TRANS/WP.29/GRSP/2005/6
9 March 2005

PROPOSAL FOR DRAFT AMENDMENTS TO REGULATION No. 44
(Child restraints)

Transmitted by the expert from France on behalf of the ad hoc group

Note: The text reproduced below was prepared by an ad hoc group in order to authorize the use of an acceleration test device for validation of the dynamic behaviour of a child restraint system.

Annex 7 – Appendix 1

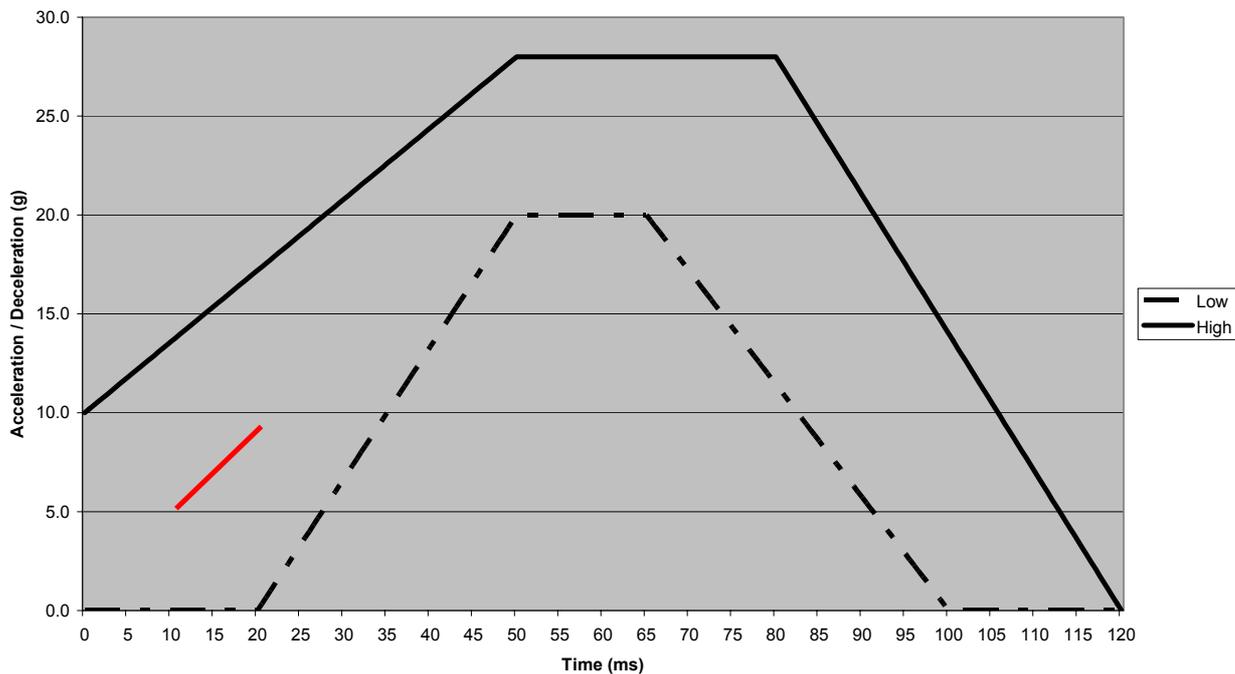
**CURVE OF TROLLEY' S, DECELERATION OR ACCELERATION,
AS FUNCTION OF TIME
(Curve for testing stopping devices)
FRONTAL IMPACT**

Test Speed: 50 (+0 ; -2) km/h
Stopping distance: 650 ± 30mm

Time (ms)	Acceleration (g) Low corridor	Acceleration (g) High corridor
0	-	10
20	0	-
50	20	28
65	20	-
80	-	28
100	0	-
120	-	0

Annex 7 – Appendix 2

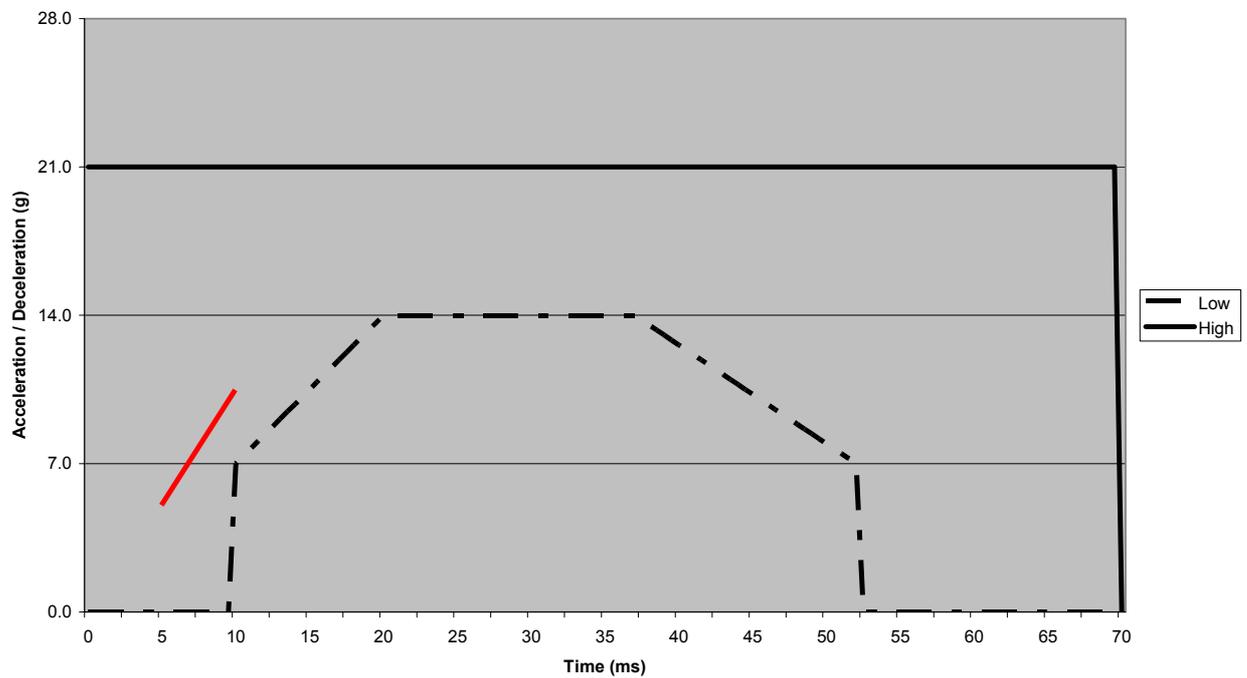
**CURVES OF TROLLEY' S, DECELERATION OR ACCELERATION,
AS FUNCTION OF TIME
(Curve for testing stopping devices)
REAR IMPACT**

~~Test Speed: 30 (+2 ; -0) km/h~~
~~Stopping distance: 275 ± 20mm~~

Time (ms)	Acceleration (g) Low corridor	Acceleration (g) High corridor
0	-	21
10	0	
10	7	-
20	14	-
37	14	-
52	7	-
52	0	
70	-	21
70	-	0
